10/761,031

Office Action Summary

WHEELER ET AL.

DETAILED ACTION

Appendix A

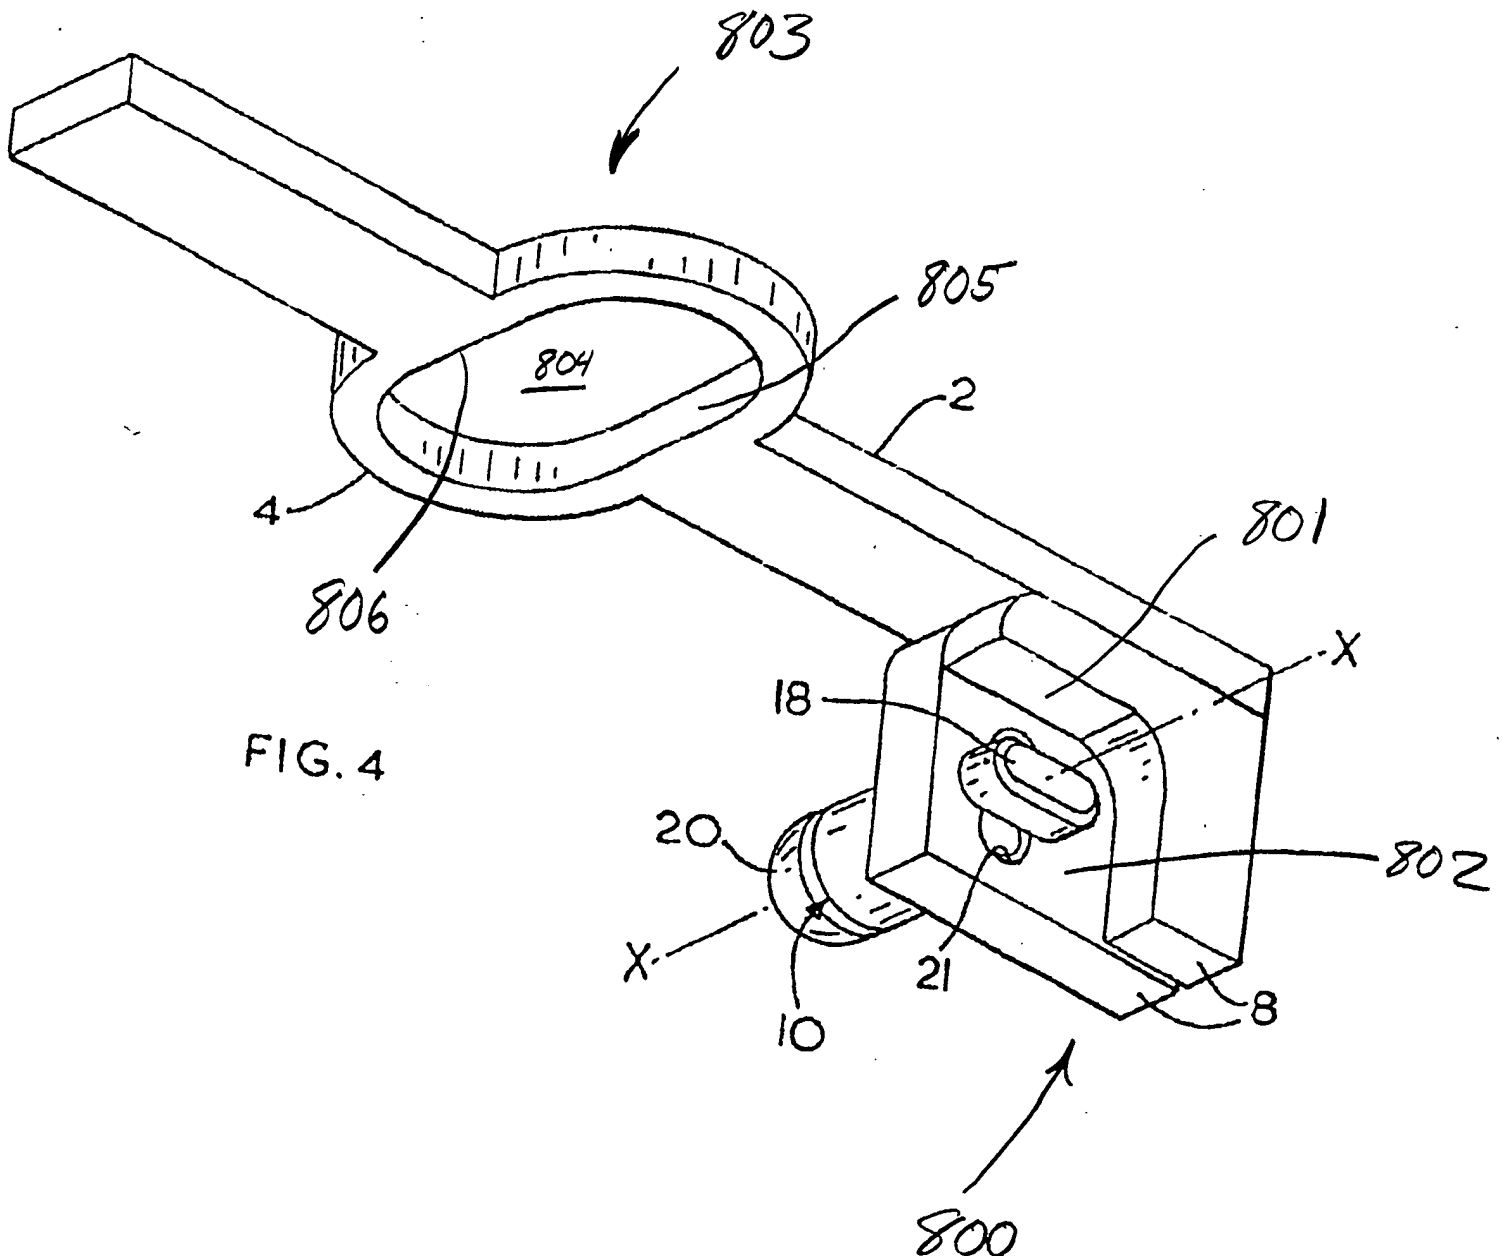
11. Claim 1 is rejected under 35 U.S.C. 103(a) as being unpatentable over Wright (6,694,625). Please see Appendix A for examiner added reference numerals.

Wright discloses the invention including a housing (36) containing a motor (24), a substantially flat planar monolithic one piece carrier slidably disposed within the housing (2), the carrier including a first portion (800) with a planar base (801) and side walls extending from and continuous with the planar base defining a channel adapted to receive a blade (802, Fig. 5), a second portion continuous with the first portion forming a one piece carrier (803), the second portion having a slot (804) with lateral side walls extending from opposing edges of the slot forming an opening through the carrier (805, 806), the carrier positioned in the housing such that a plane of the base is in a line of cutting with the saw blade so that the plane of the line of cutting is substantially parallel to the plane of the planar base (Fig. 5), a rotatable element fixed for rotation about a support and rotated by the motor (30), a follower for interconnecting the carrier and the

13. Claim 11 is rejected under 35 U.S.C. 103(a) as being unpatentable over Wright. Please see Appendix A for examiner added reference numerals.

Wright discloses the invention including a housing (36) containing a motor (24), a saw blade having a cutting edge, a mounting edge, and a side surface (12), the side surface defining a first plane in a line of cut with the cutting edge (Fig. 5), a monolithic one piece carrier (2) including a first portion (800) defining a channel adapted to receive a blade (802, Fig. 5), the channel including a base defining a second plane (801) and walls extending from and continuous with the base and substantially perpendicular to the second plane (8), the first plane is parallel to the second plane and the first plane is resting on the second plane (Fig. 5), a second portion continuous with the first portion forming a one piece carrier (803), the second portion having a slot (804) with lateral side walls extending from opposing edges of the slot forming an opening through the carrier defining a path (805, 806), a rotatable element rotated by an output shaft extending
